RADIO RECEIVERS R-274/FRR, R-274A/FRR, R-274C/FRR, AND R-274D/FRR

TM 11-897

CHANGES No. 2

CHANGES }
No. 1 }

Figure 2.1. (Added) Radio receiver R-274D/FRR, rear view.

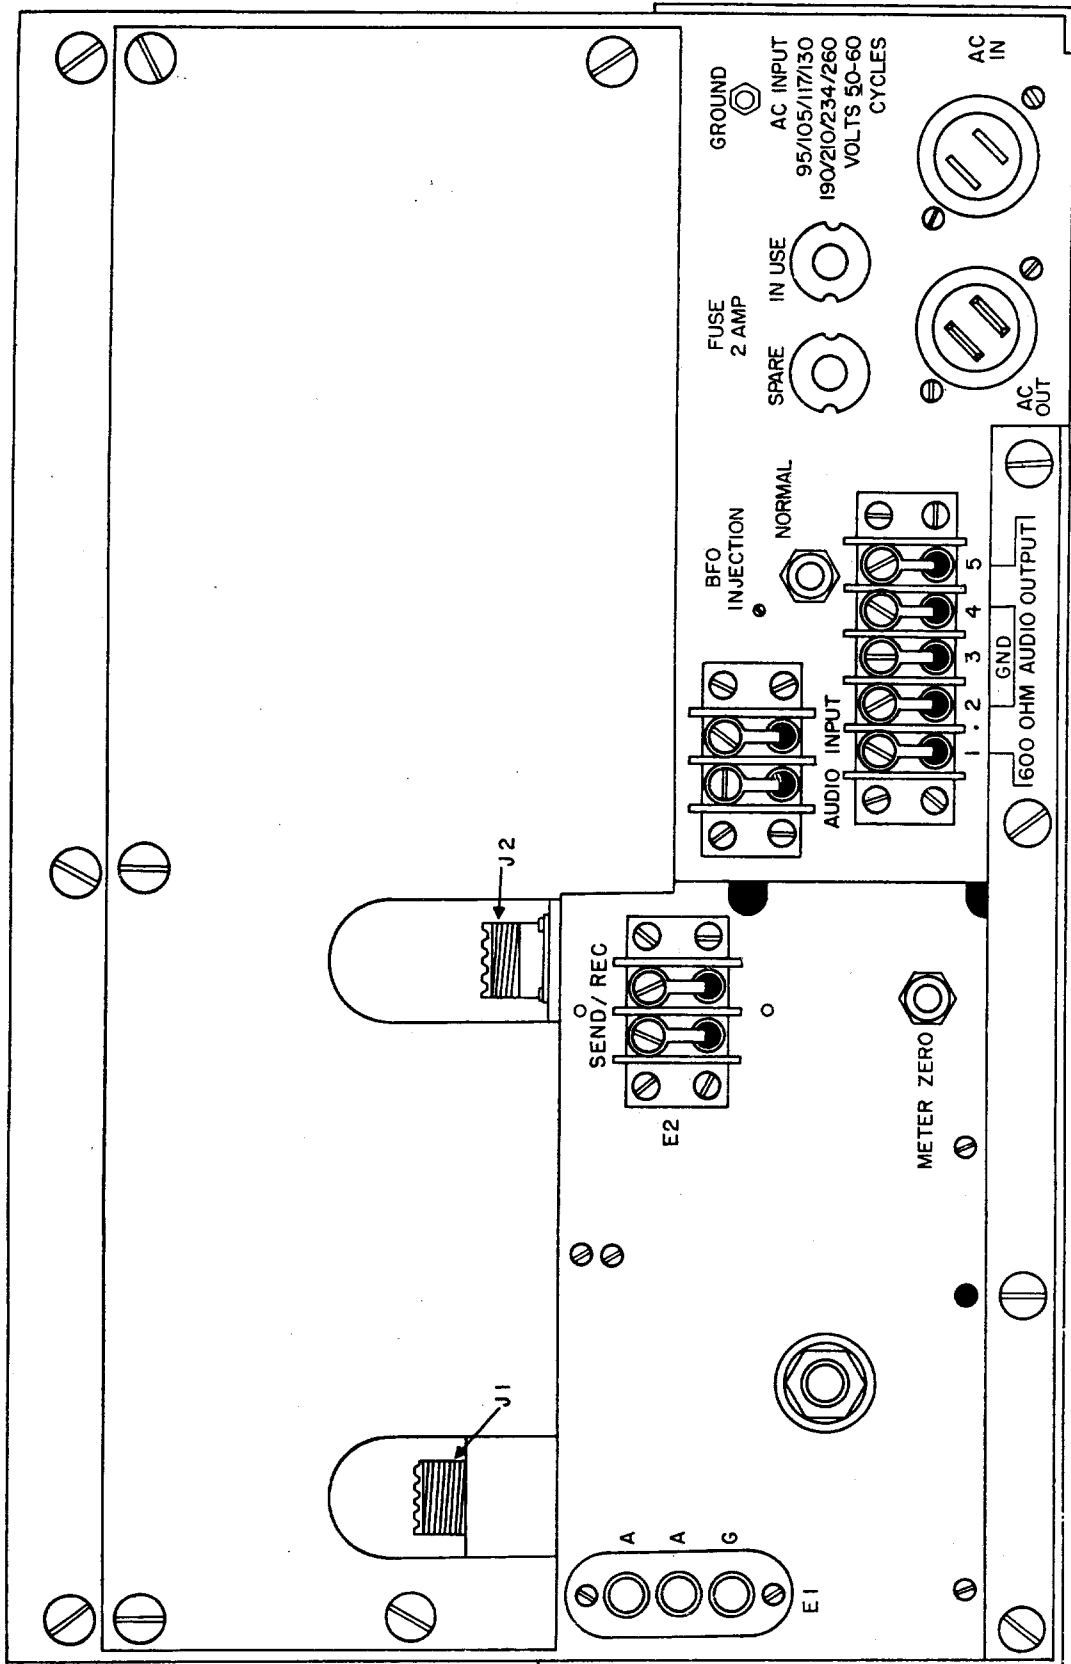
The design of Radio Receiver R-274D/FRR includes an antenna disabling relay which was not used in the unlettered model. This relay (K2) shorts the receiver to ground, thereby preventing damage to the receiver antenna coils during transmission. The relay is mounted under the chassis near the rear of the rf turret (fig. 32.1). On Order No. 3464-Phila-52, serial numbers 674 through 1266, a neon lamp (E53) has been added across the antenna contacts of the antenna disabling relay K2 (fig. 14.1). In addition to this modification, other minor changes have been made. They are as follows:

a. Terminal strip E2, used for remote standby operation in the B+ circuit, now is used to connect disabling relay coil K2 to external circuits.

b. Capacitor C77 is deleted from the circuit.

c. The band numbering is from 1 through 6 instead of I through VI.

d. The lettering on the rear panel is revised (fig. 2.1).

Figure 14.1. (Added) Radio receiver R-274D/FRR, antenna disabling relay schematic.

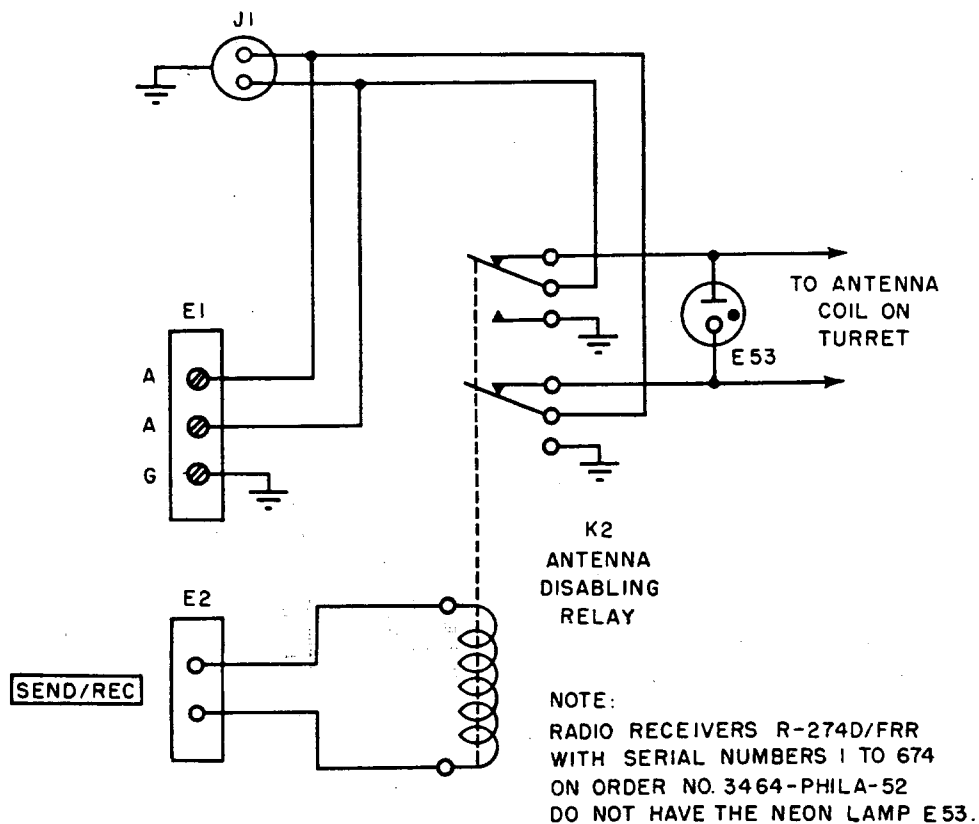
- b. In the partial * * * terminal A of E1. In Radio Receiver R-274D/FRR the signal from

antenna connectors E1 and J1 must pass through the contacts of relay K2 before reaching the antenna coil. The relay is normally in the receive (REC) position with the antenna connected to the antenna coil. The relay is actuated to the SEND position by application of 12 volts dc at the termi-

nals of E2 from an external source. In this position, the antenna input leads are both grounded to the chassis through a set of relay contacts and the antenna coil is an open circuit. This prevents the transmitter rf radiation from causing damage to the antenna coil. A neon lamp is connected across the antenna disabling relay contacts on serial numbers 674 through 1266 of Order No. 3464-Phila-52. This lamp prevents damage to the antenna coil due to the high voltage static surges. Figure 14.1 is a schematic diagram of the relay circuit. Capacitor C22 (ANT ADJ) * * * lower frequency band.

Figure 32.1. (Added) Radio receiver R-274D/FRR, rf chassis bottom view.

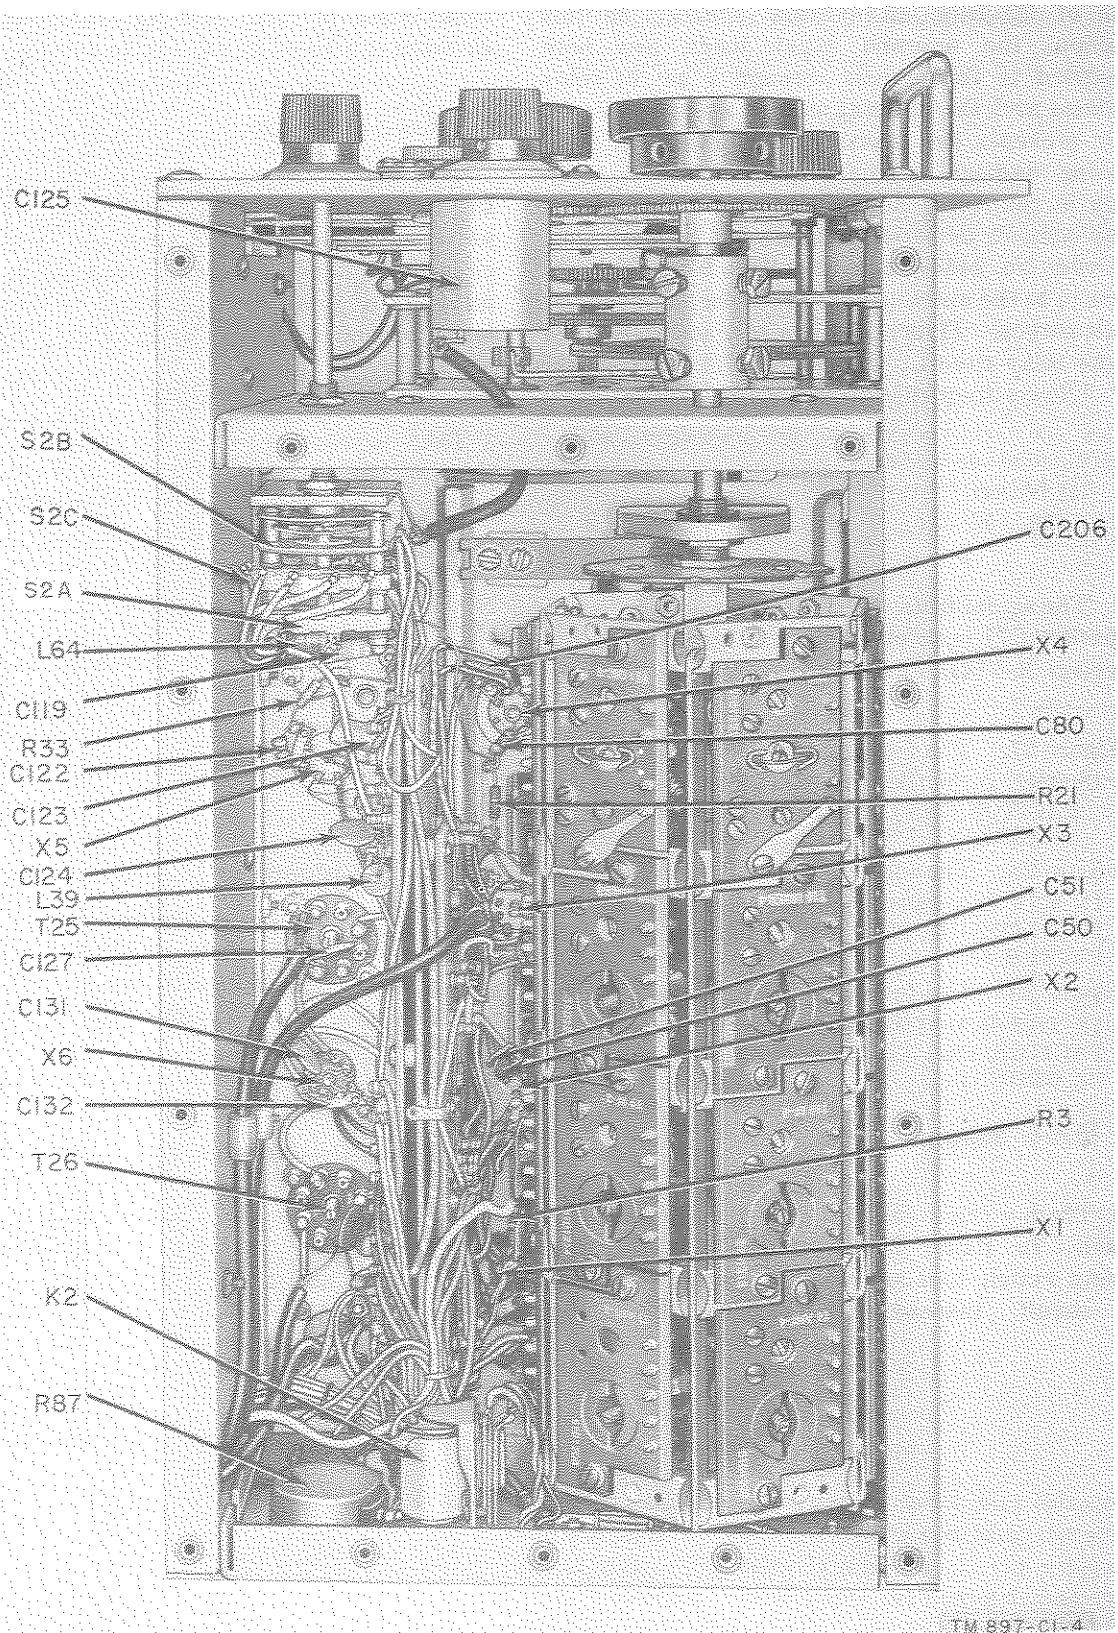
Fig. No.	Title
32	Radio * * * view.
32, 1	Radio Receiver R-274D/FRR, rf chassis bottom view.
43	Radio * * * diagram.
43, 1	Radio Receiver R-274D/FRR, schematic diagram.

* * * * *
e. R-f Turret (figs. 32 and 32.1). The removal of * * * chassis as follows:
